**216 Grandview Avenue – Weinberger Subdivision
Village of Montebello
Underdrain Report – Lots 21, 22 and 24**

March 24, 2025

This Underdrain Report was revised in response to comments provided by Spence Engineering dated March 23, 2025. The as-built inverts and the design rim elevation and the as-built rim elevations for CB 38A and CB 15 have been provided.

GRADING, DRAINAGE & UTILITY PLAN (SECTION A)

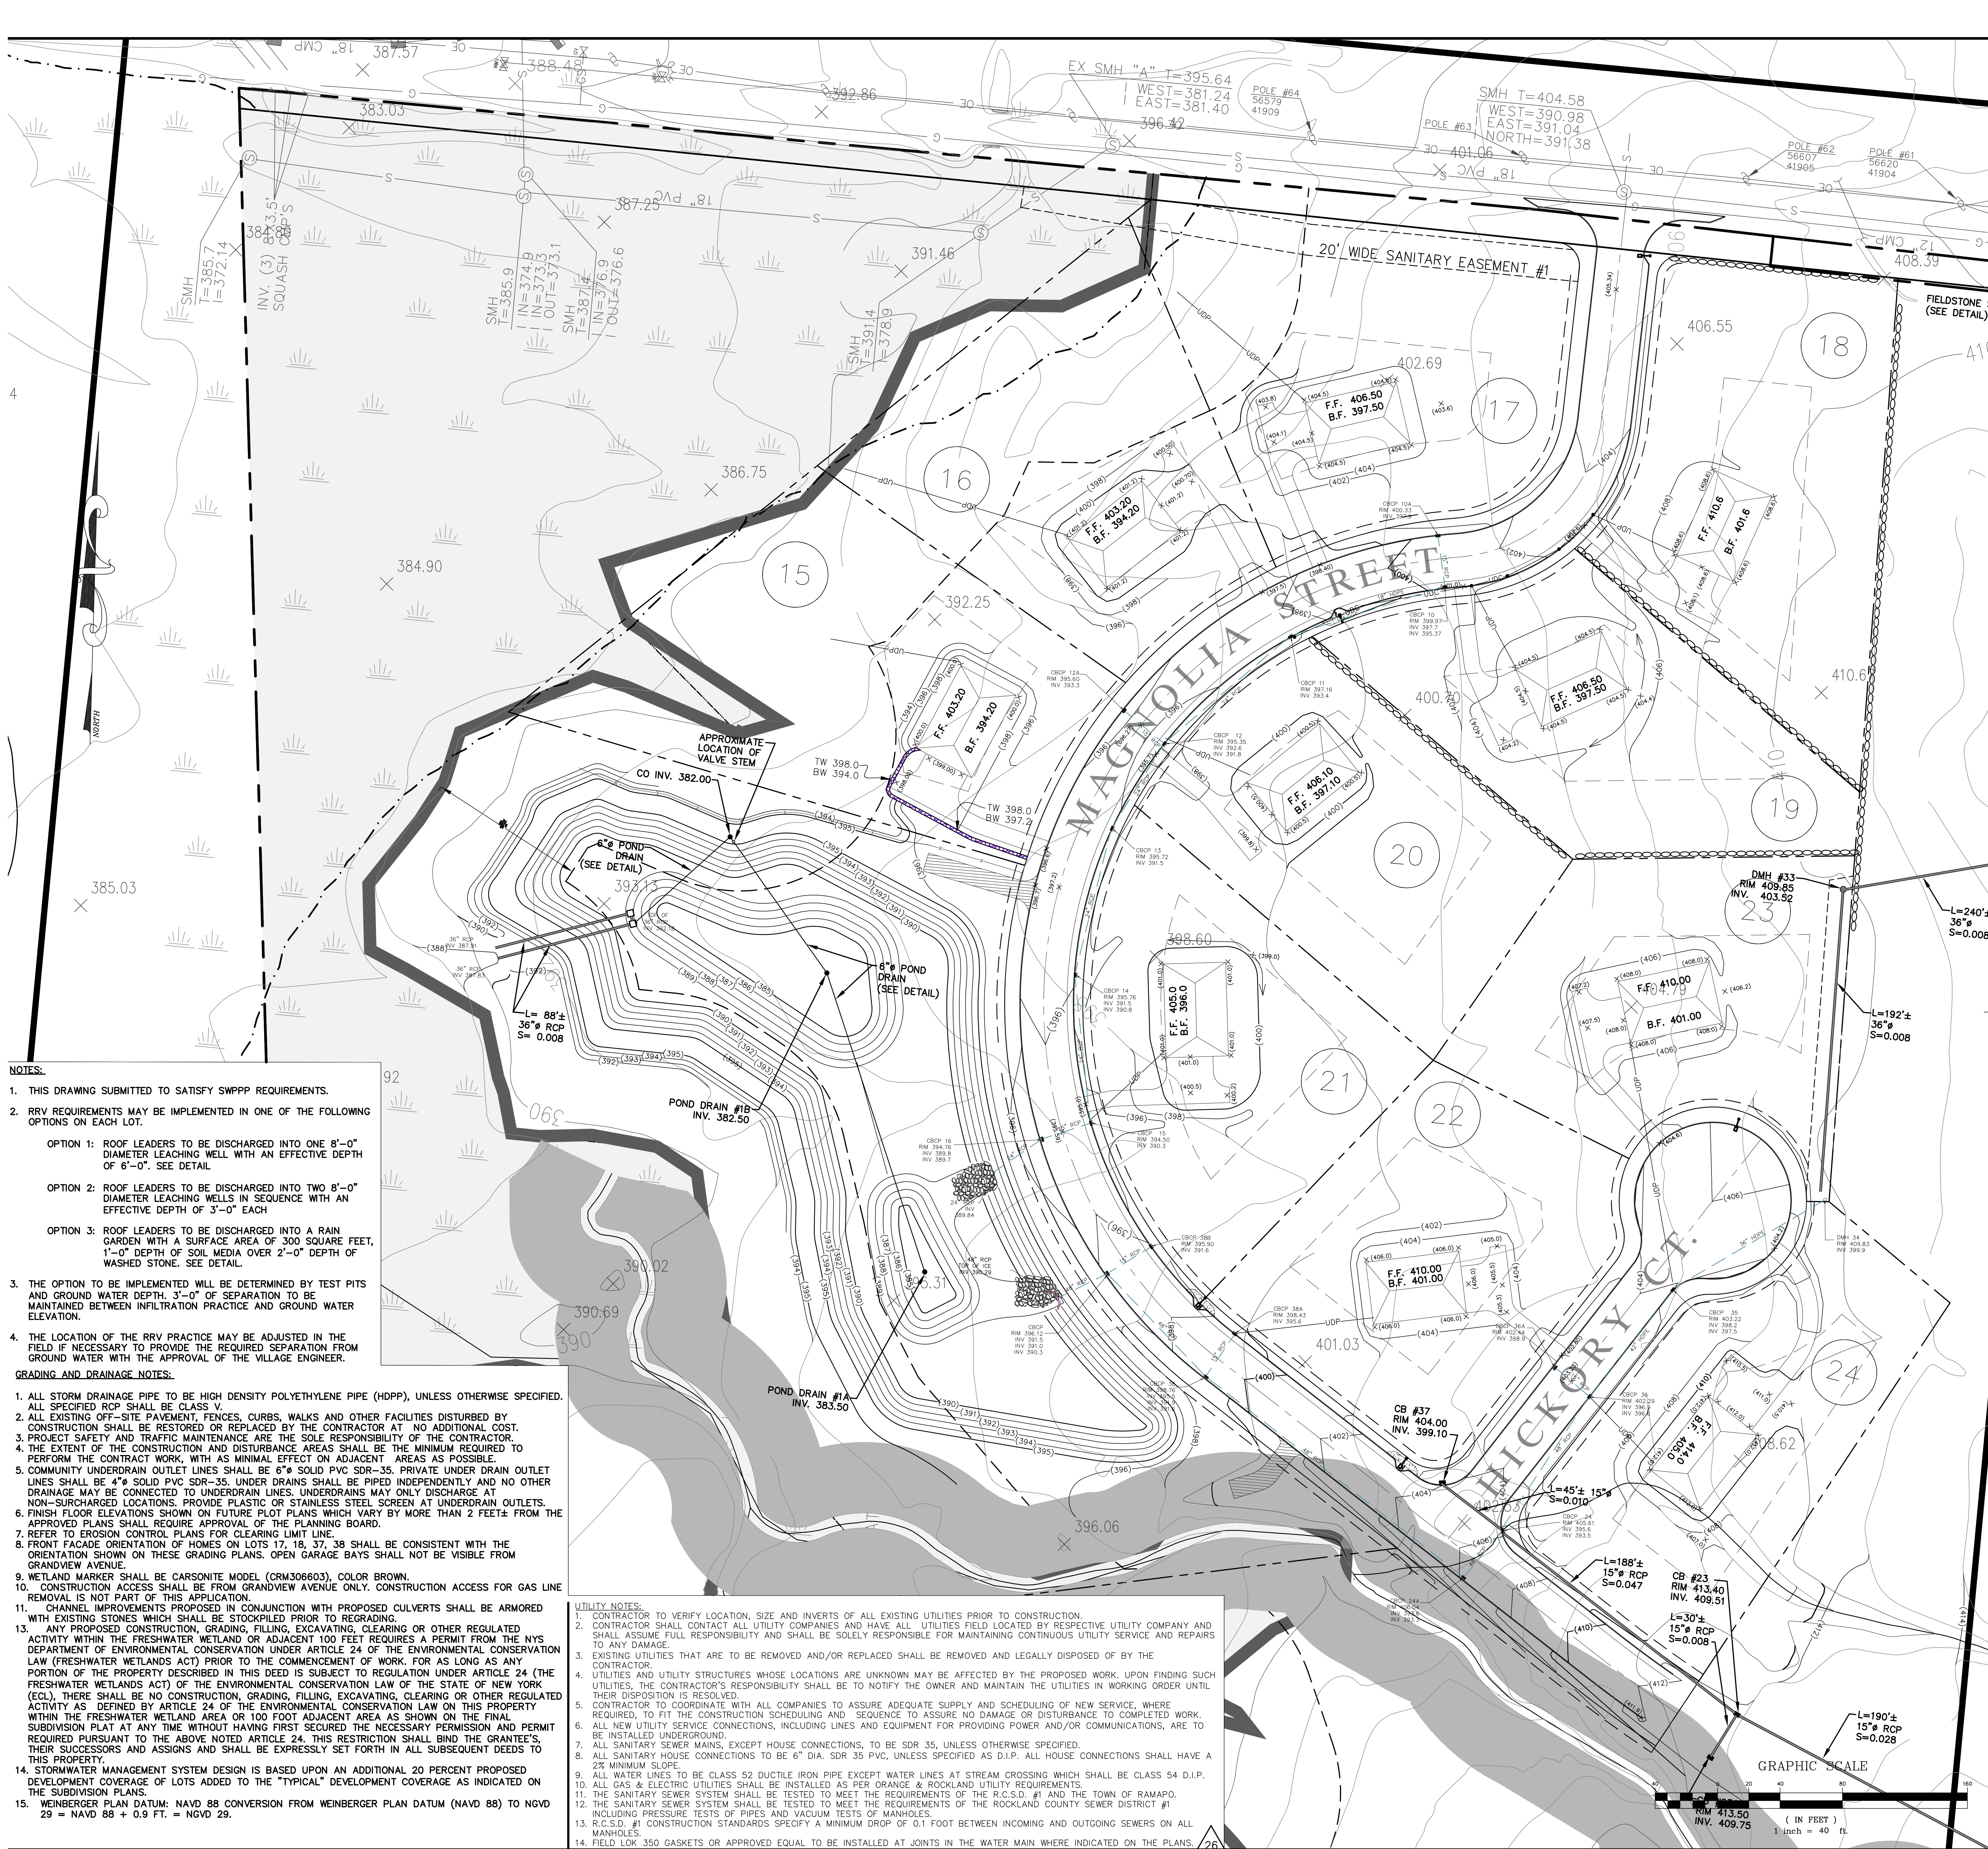
We propose to provide an underdrain (See the foundation underdrain detail Dwg. # 33) connection to proposed CB # 36 (design rim elevation 402.78) in Hickory Court. The as-built survey determined the existing rim of this catch basin is 402.29 with an invert of 396.6. The 4"Ø underdrain to be constructed with an invert of 400.75 into the catch basin.

We propose to provide an underdrain (See the foundation underdrain detail Dwg. # 33) connection to proposed CB # 38A (design rim elevation 398.6) in Magnolia Street. The as-built survey determined the existing rim of this catch basin is 398.43 and the invert is 395.6. The 4"Ø underdrain to be constructed with an invert of 396.1. into the catch basin.

We propose to provide an underdrain (See the foundation underdrain detail, Dwg. # 33) connection to proposed CB # 15 (design rim elevation 394.96) in Magnolia Street. The as-built survey determined the existing rim of this catch basin is 394.5 and the invert is 390.3. The 4"Ø to be constructed with an invert of 392.2 into the catch basin.

THE CATCH BASIN AS-BUILT SURVEY WAS PERFORMED ON FEBRUARY 27, 2025 BY CIVIL TEC ENGINEERING AND SURVEY.
